Report to the Plan Commission

Legistar I.D. #17823
3604-3704 Agriculture Drive
Preliminary & Final Plat

Requested Actions: Approval of a preliminary plat and a final plat creating 16 industrial lots at 3604-3704 Agriculture Drive.

Environmental Corridors
Central_Map_G10
Dane County, Wisconsin

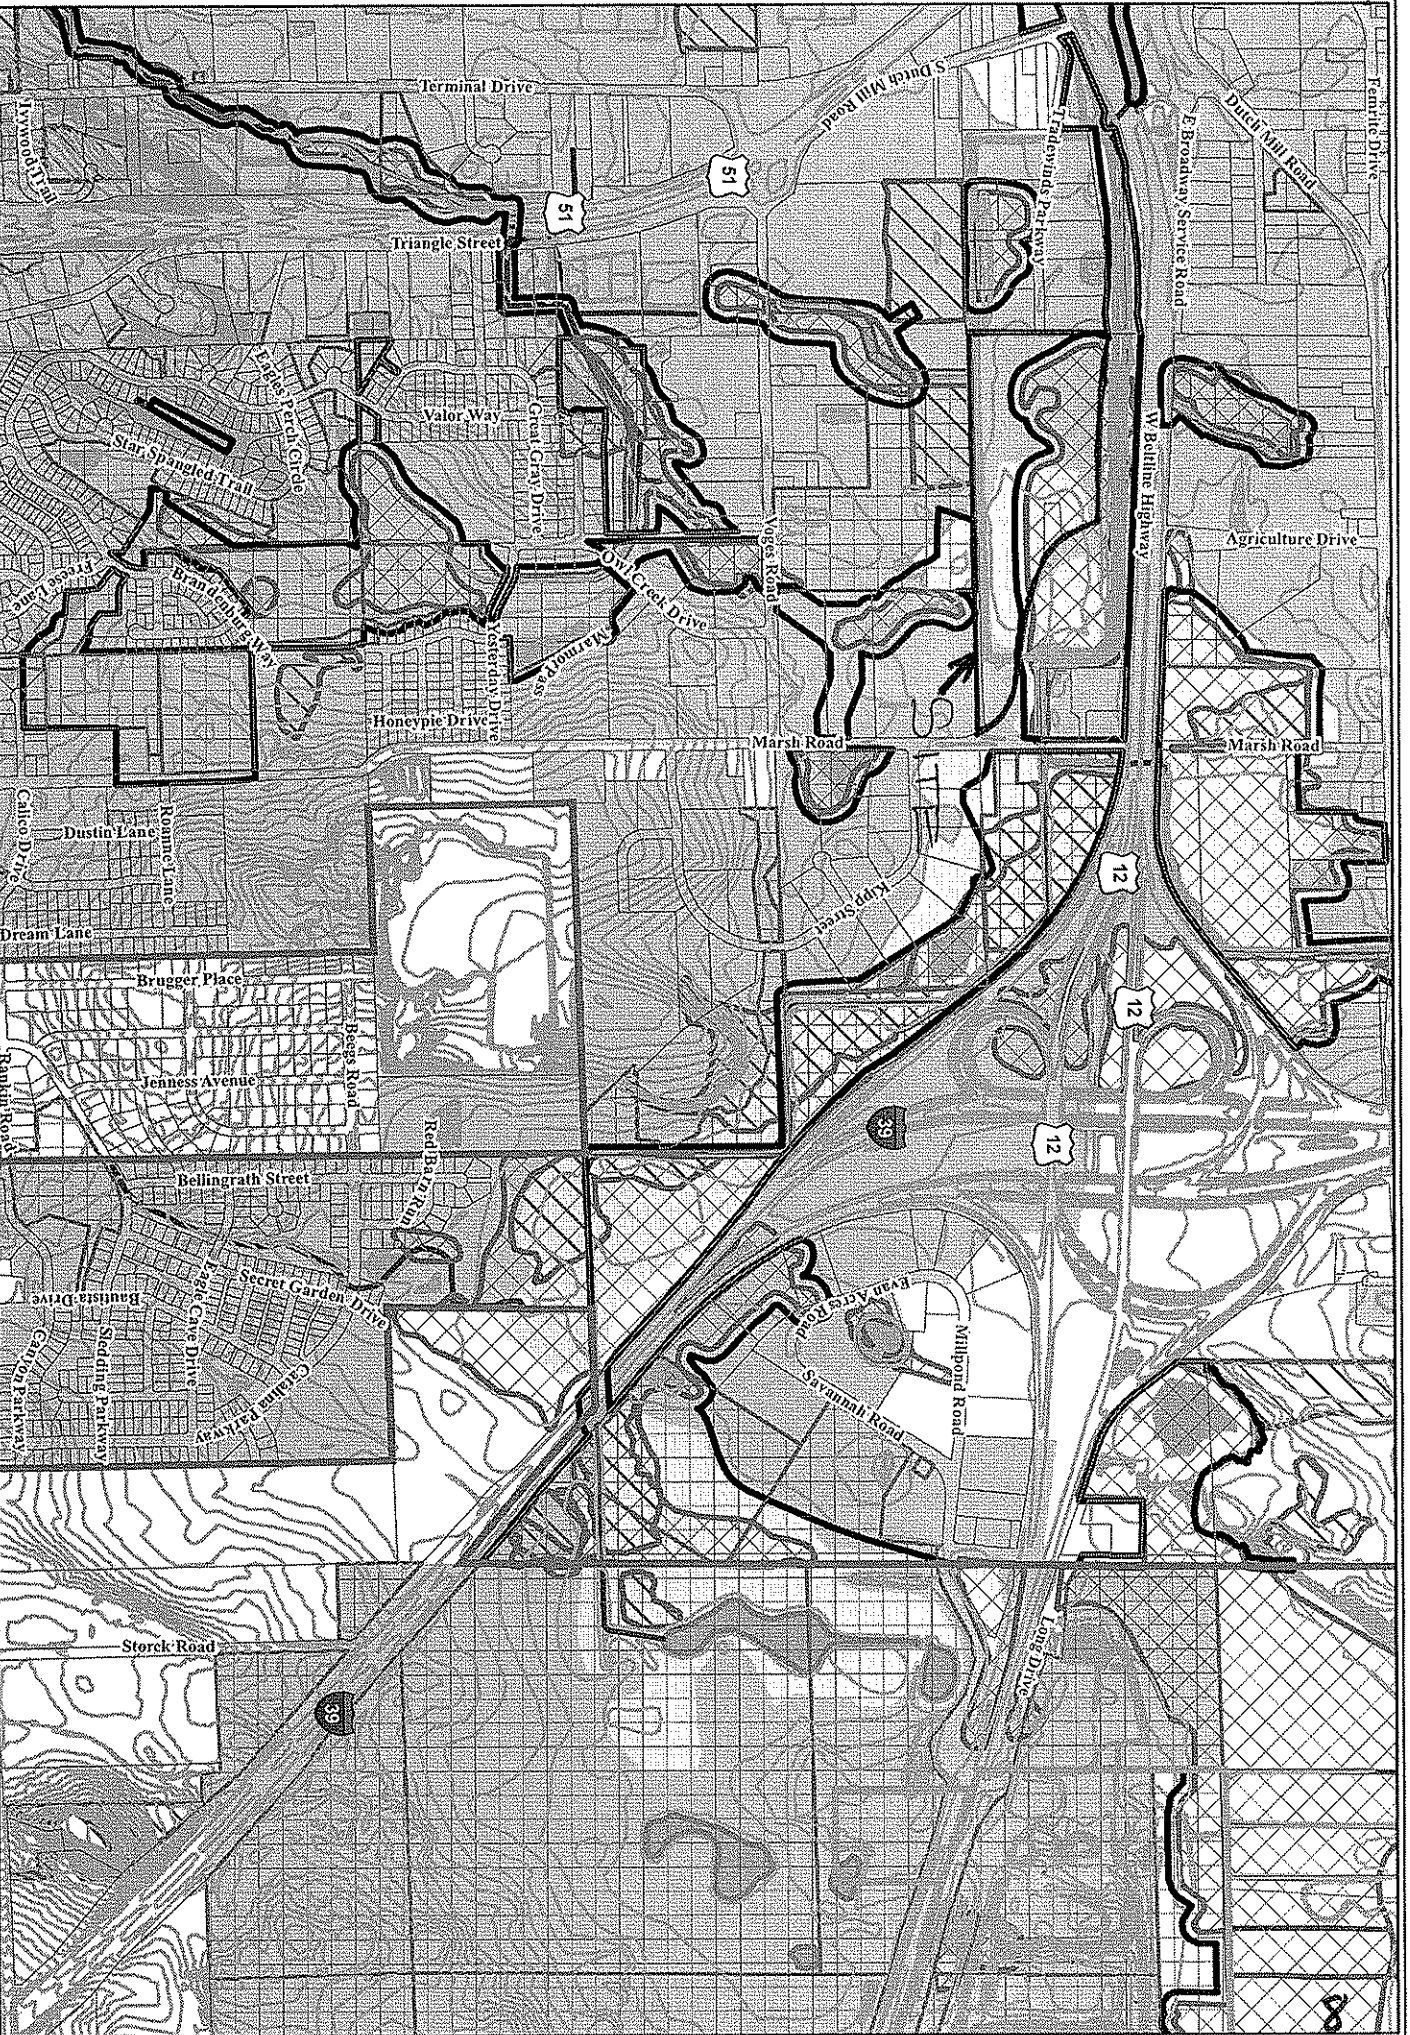
Environmental corridor mapping shows a floodplain and adjacent wetlands extending along the northerly edge of the site corresponding to low-lying lands near Agriculture Drive (see attached map). These conditions are related to the mapped perennial stream on the WisDOT property to the north, and related to existing conditions prior to relocation of that stream by WisDOT. The lands within the proposed subdivision were previously state lands that were purchased for use as a construction staging area and for disposal of dredged materials from Beltline reconstruction work further west of the site over the Yahara River. The floodplain is not delineated, and staff recommends that the final plat be revised to identify the final location of those conditions. The applicant has been working with the City Engineering Division and the Wisconsin Department of Natural Resources (WDNR) on a plan to remediate portions of the floodplain as part of this development. A Letter of Map Revision issued by the WDNR will be required as part of the submittal of the final plat of this project signifying that the remedial measures have been approved.
